**PALM BEACH COUNTY
PLANNING, ZONING AND BUILDING DEPARTMENT
ZONING DIVISION**

Application No.: ZV/DOA-2010-01728
Control No.: 1984-00152
Applicant: Siemens Group, Inc.
Owners: Mizner Trail Golf Club Ltd
Agent: Urban Design Kilday Studios - Wendy Tuma
Telephone No.: (561) 366-1100
Project Manager: Wendy Hernandez, Zoning Manager

TITLE: a Development Order Amendment **REQUEST:** to modify and redesignate uses, and add Pod's (Tracts), units, and access points on the Master Plan.

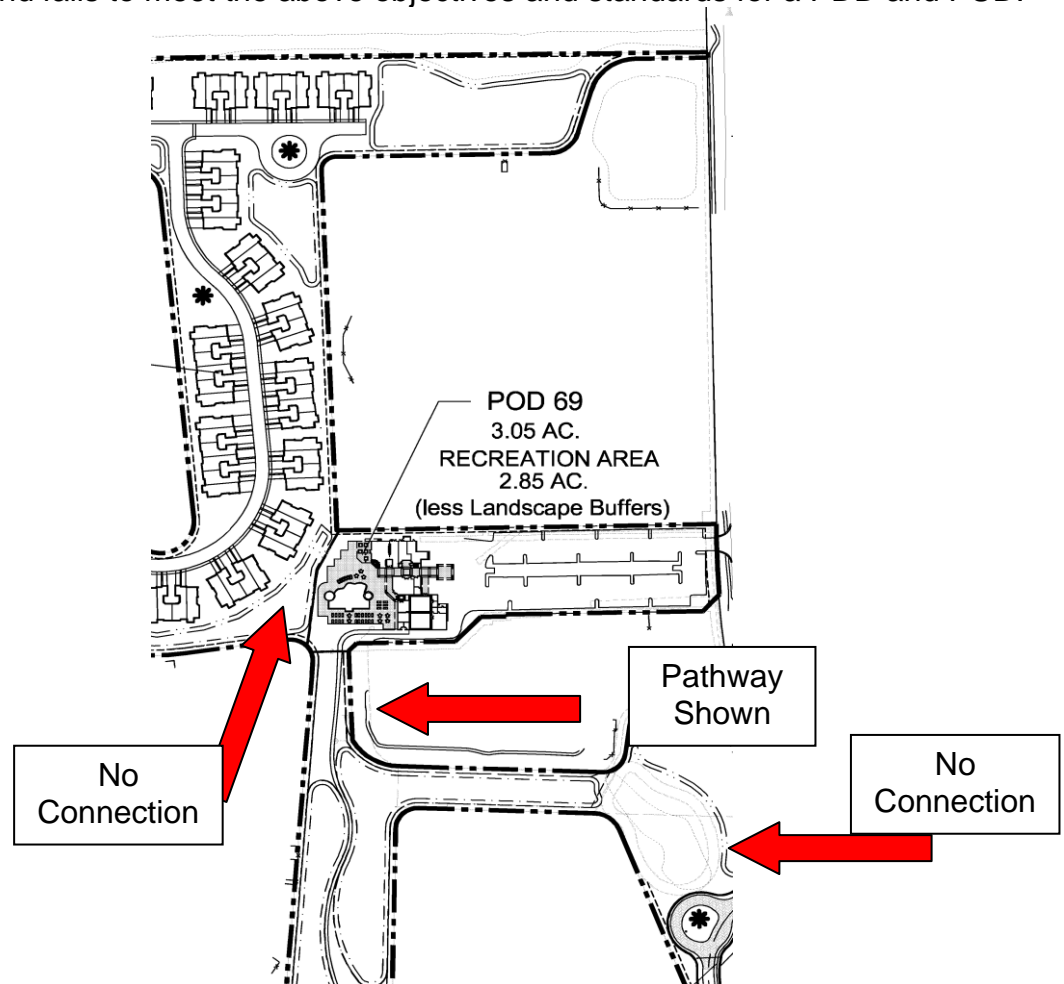
The graphic above is one example where inter-connectivity is not provided from the adjacent residential tracts to the park and recreation facility. The layout and function of the new tracts do not interrelate to one another as a PUD should be designed with cross connection minimizing access points along existing internal roads. In addition, the proposed access roads serve few

Figure 9 of 7

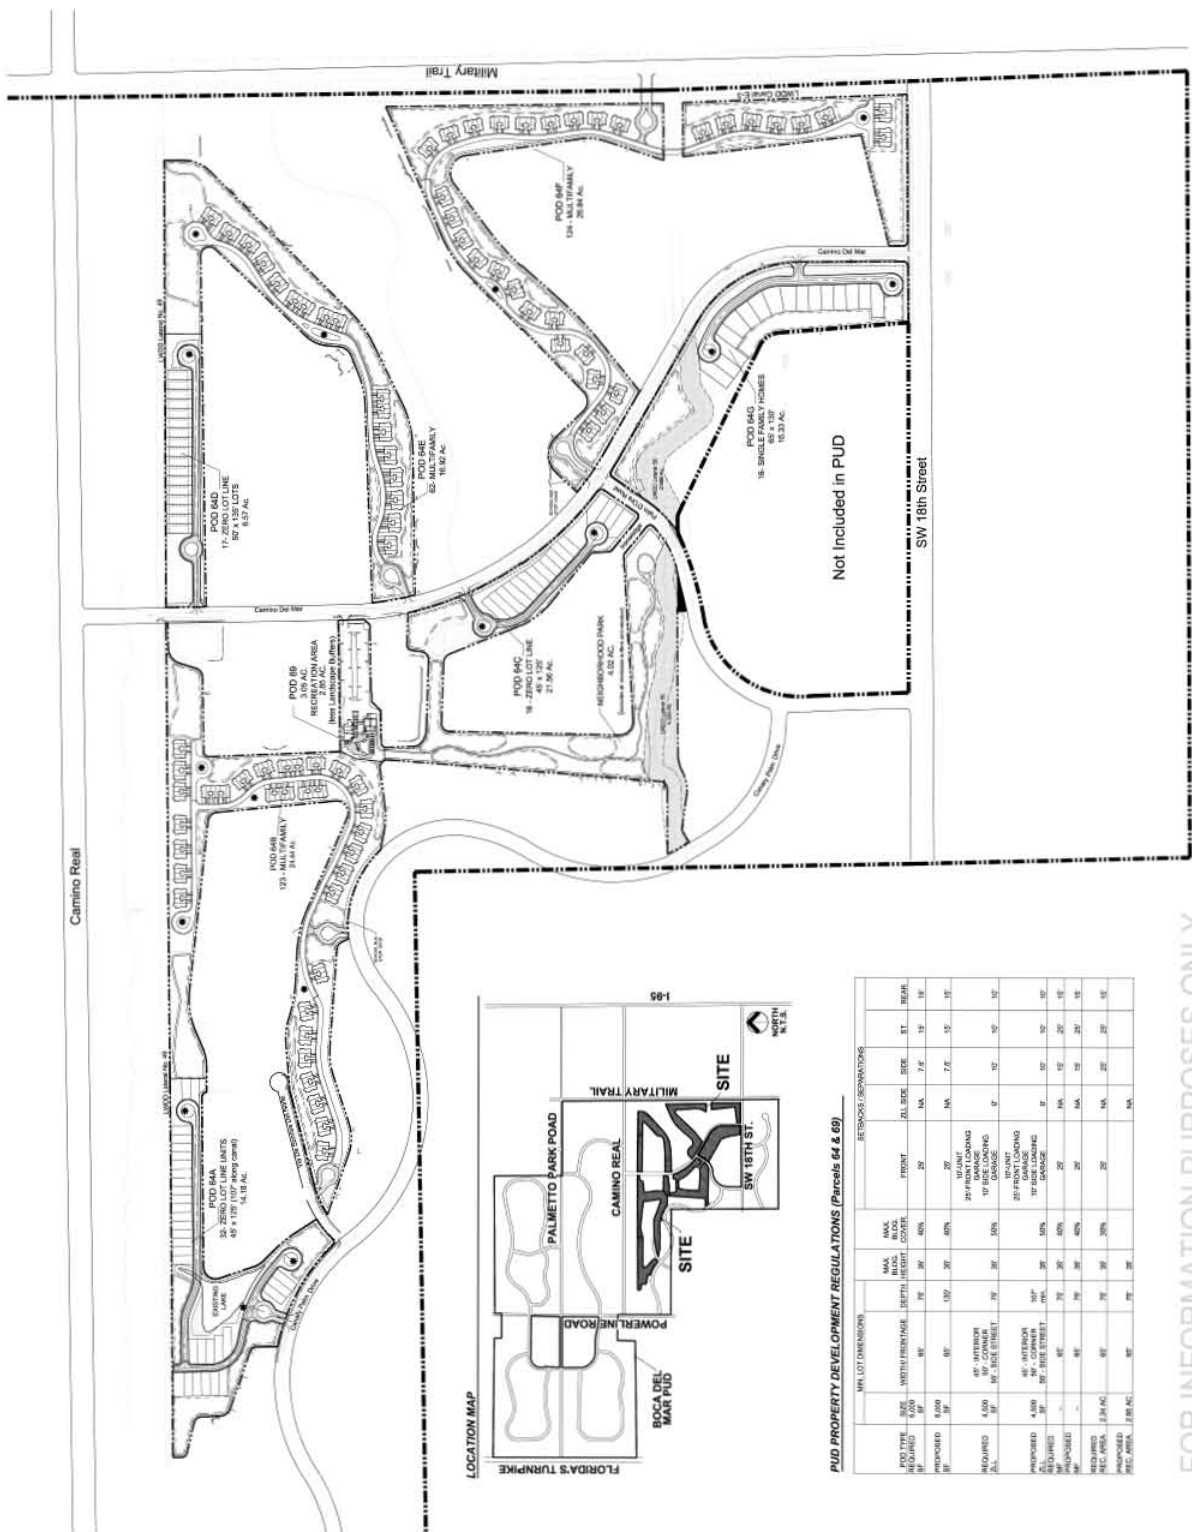
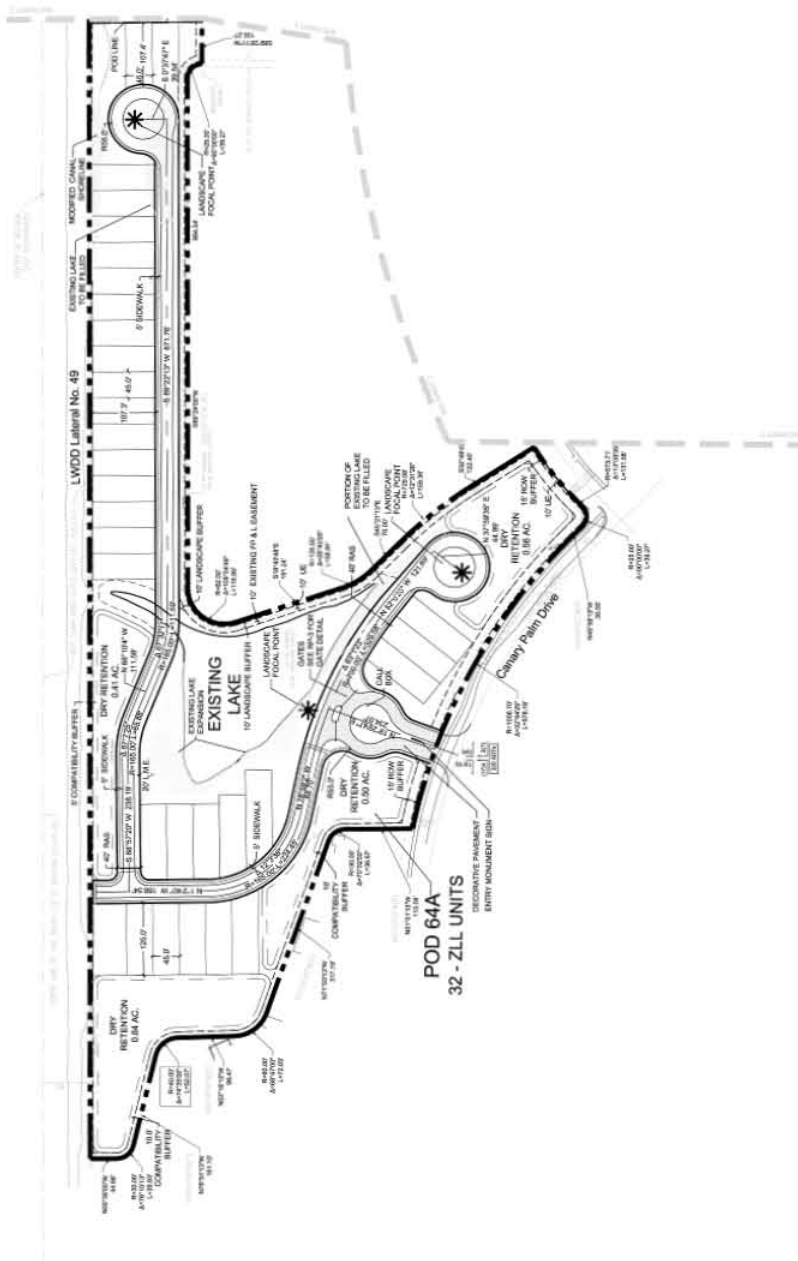
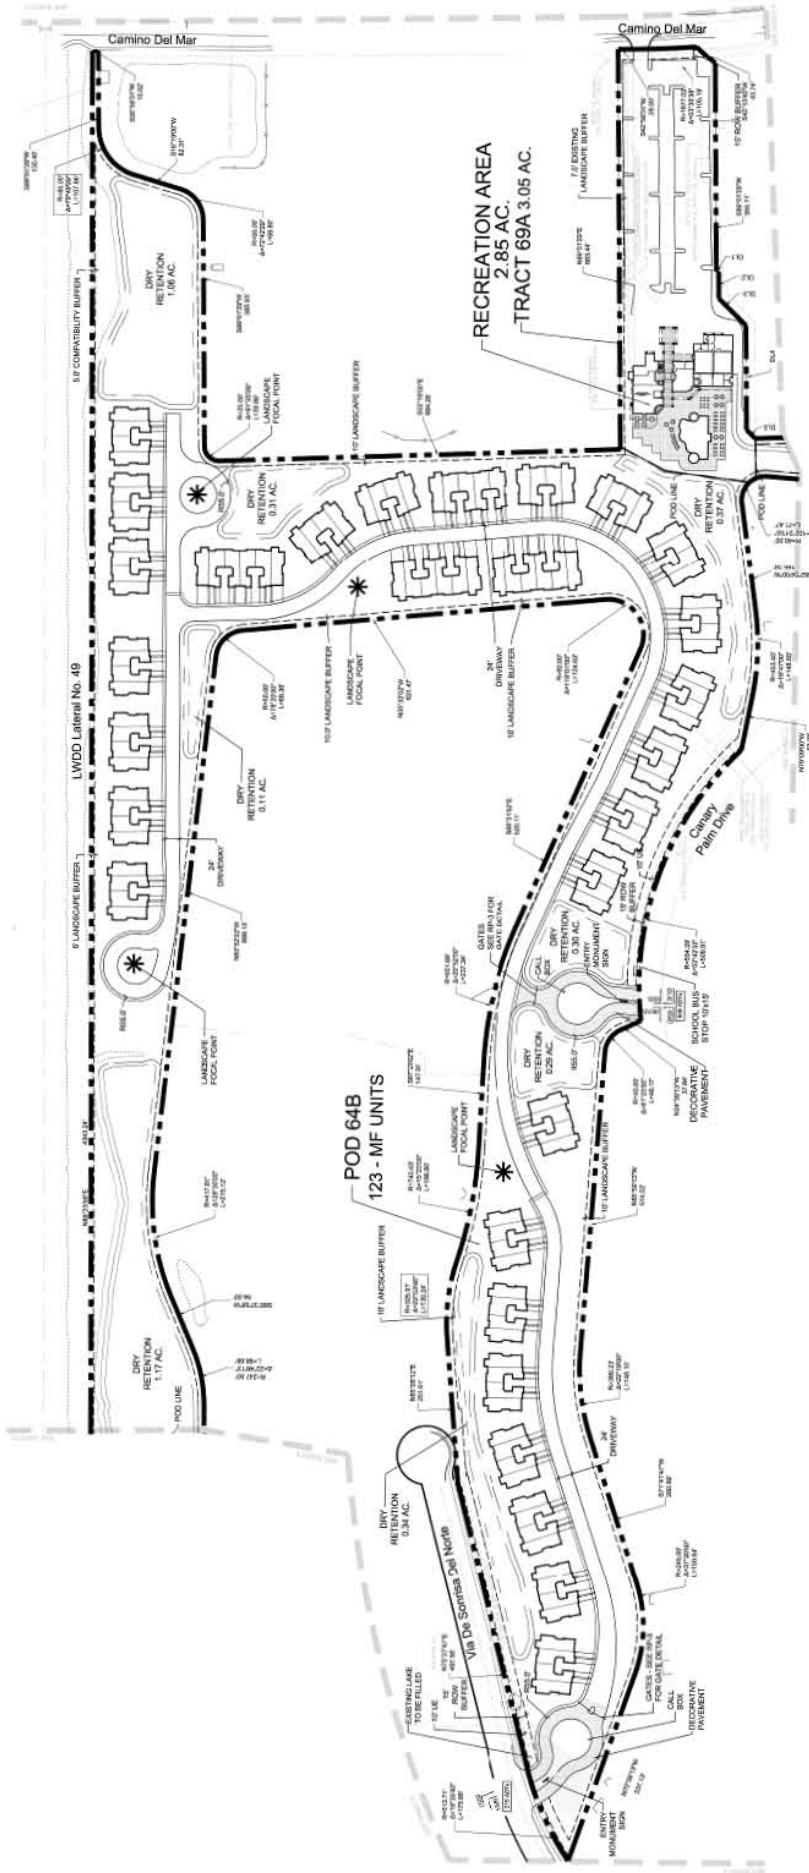
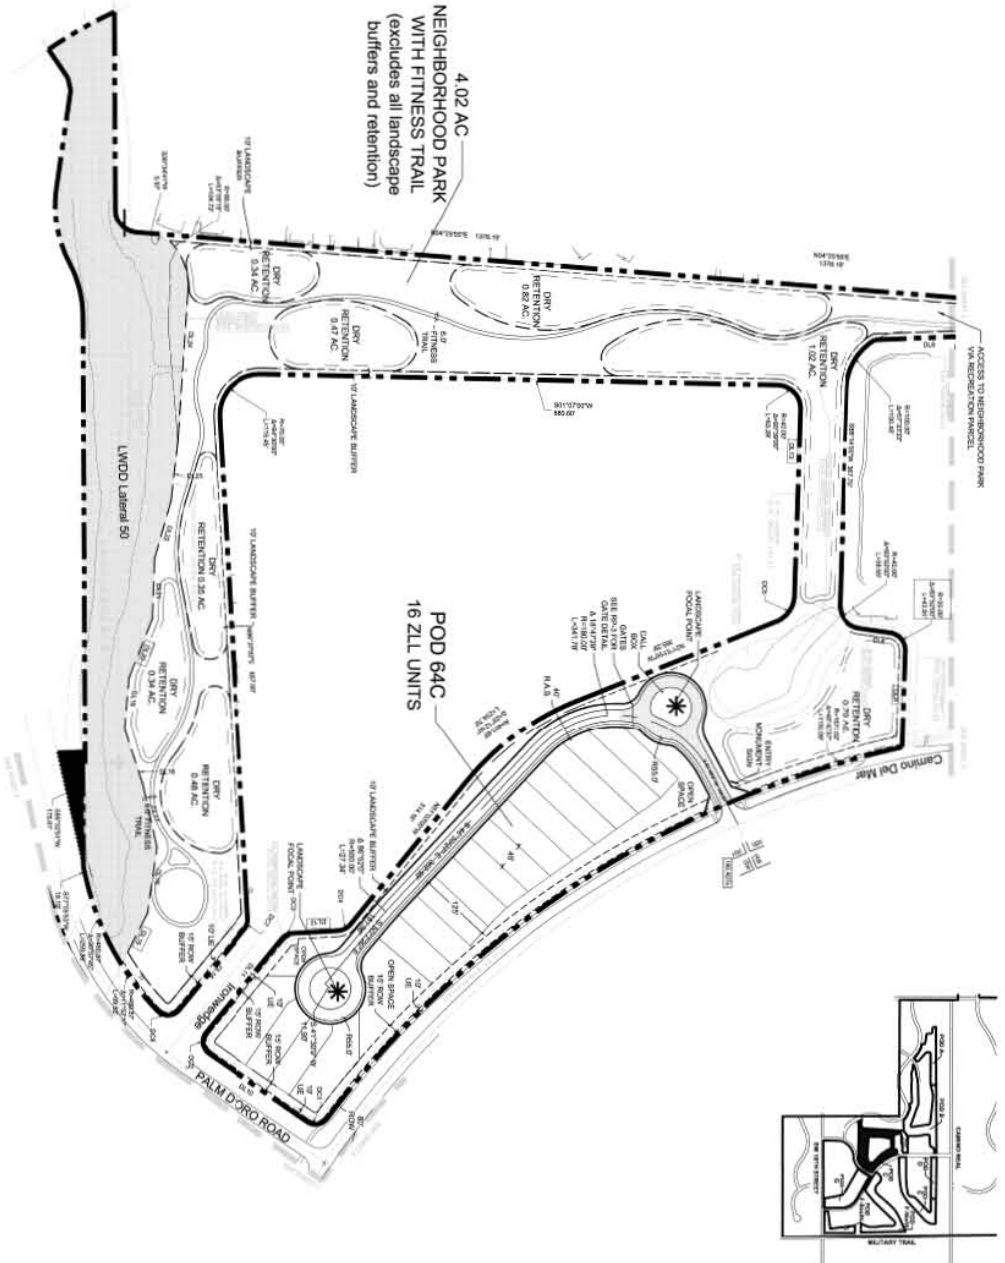
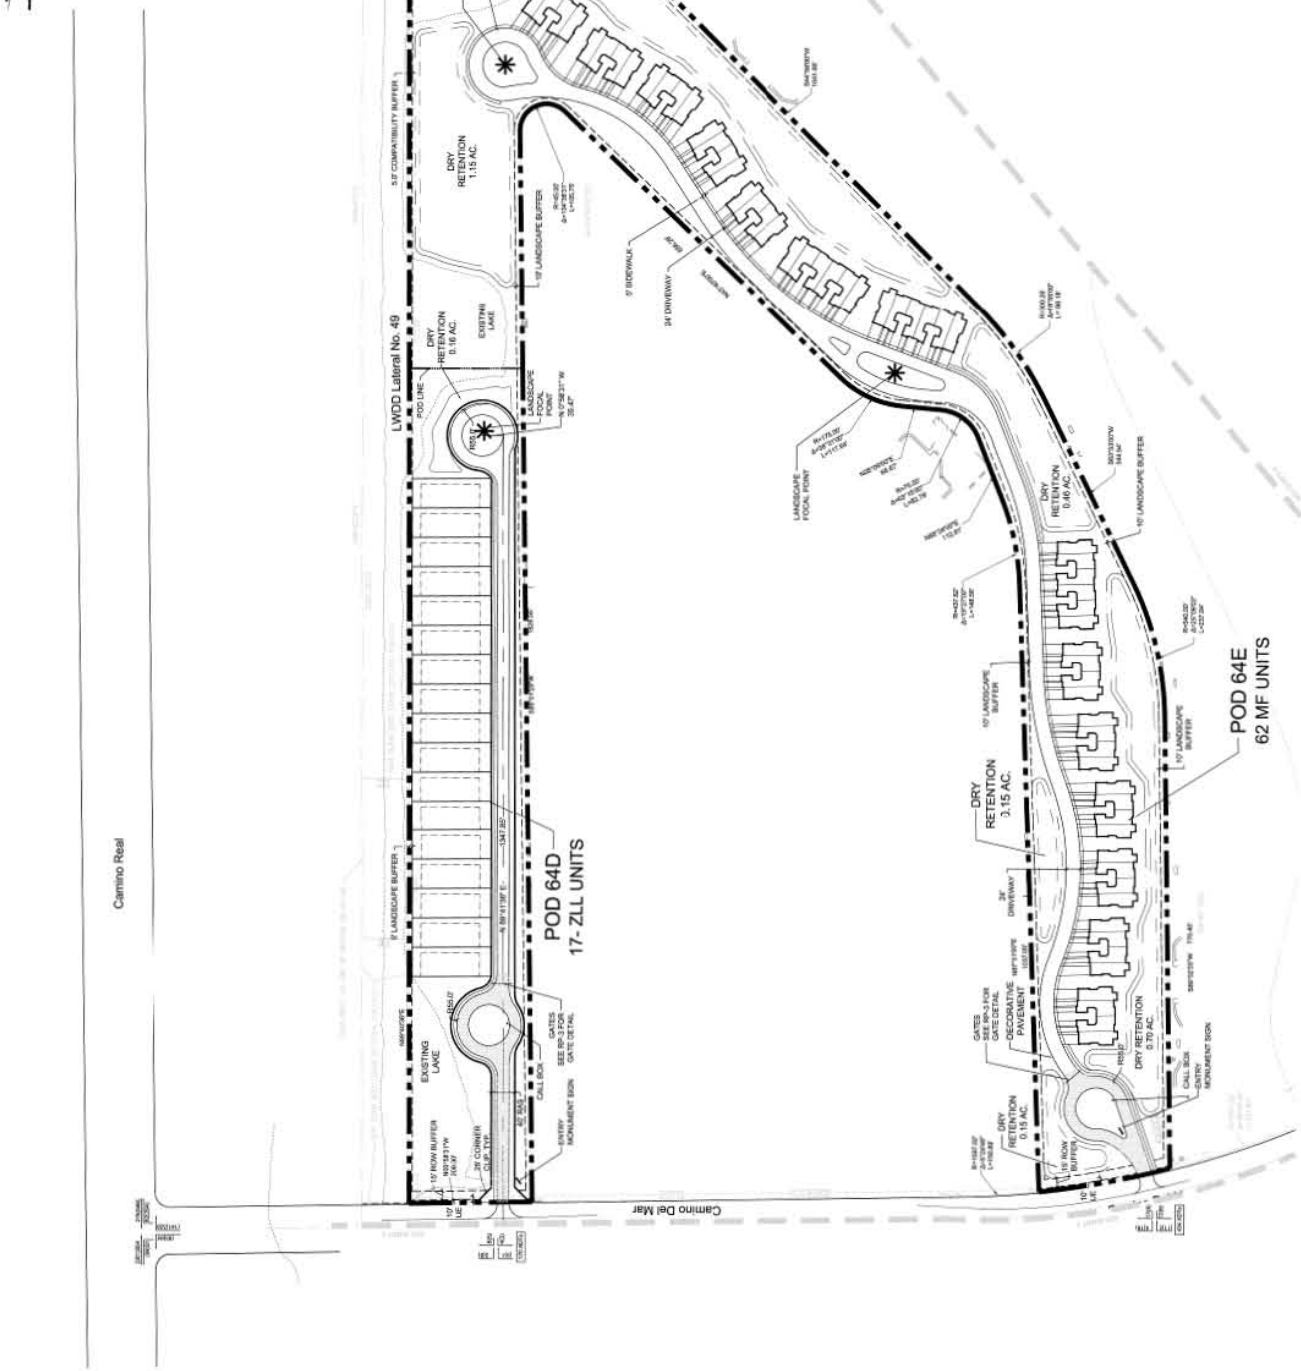
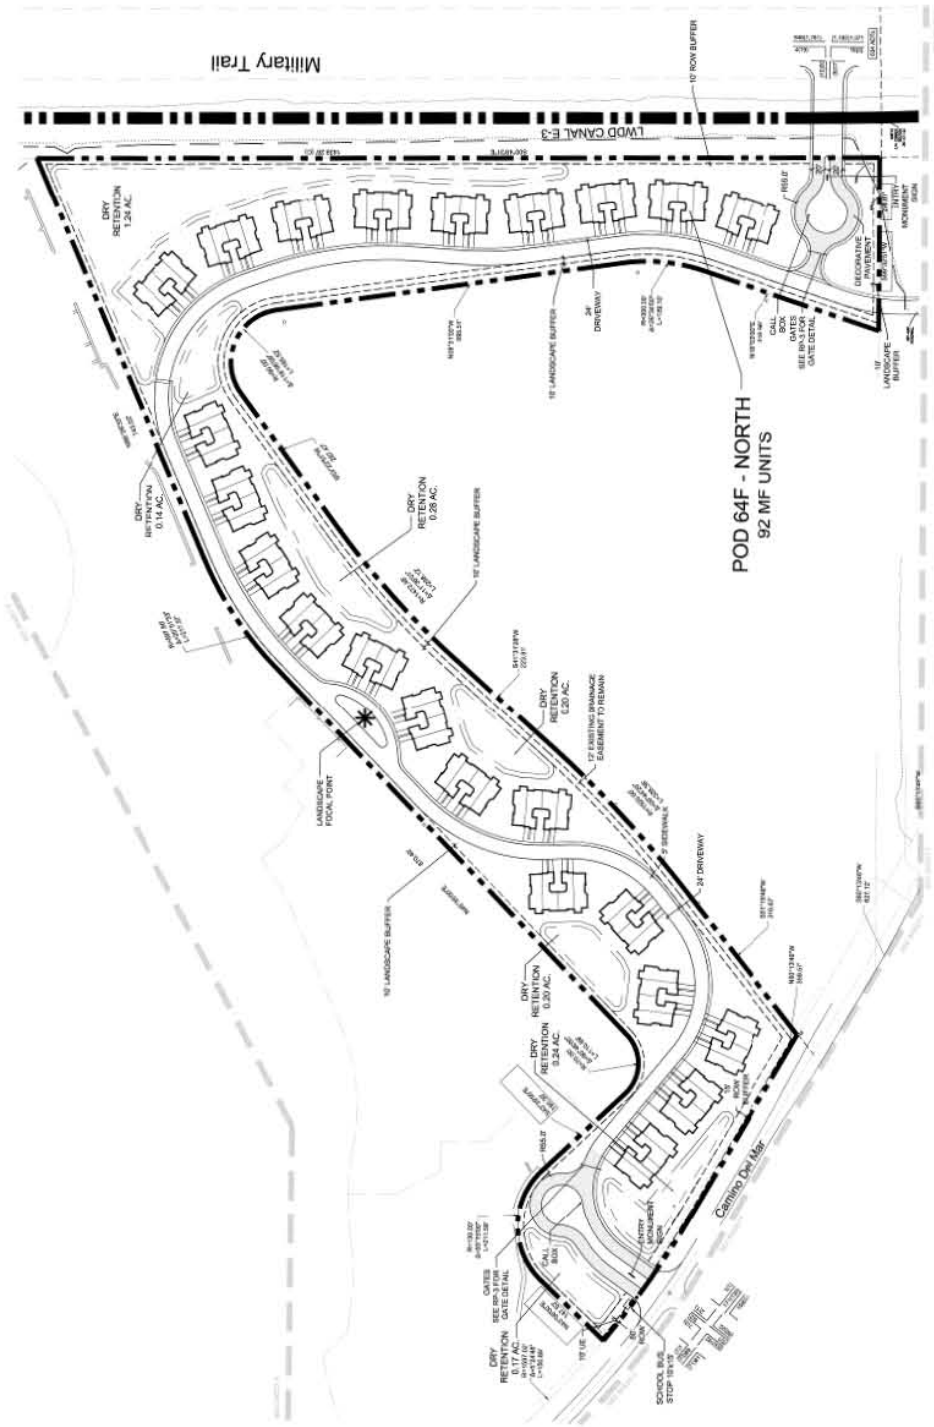
residential units due to the narrow configuration of each pod. As seen in the Figure 9, the Preliminary Site/Subdivision Plan and the Figure 10 Visual Impact Analysis, these graphics clearly indicate that the applicant is creating new roads, each of which ends in cul-de-sacs.

- Building placement for the zero lot line and single family homes are situated in a standard layout on roads with minimal or no curvature;
- Plan layout is one-sided in almost all cases due to the narrow lot configuration and proposed intensity. The applicant could have proposed a more varied configuration if the number of units were reduced;
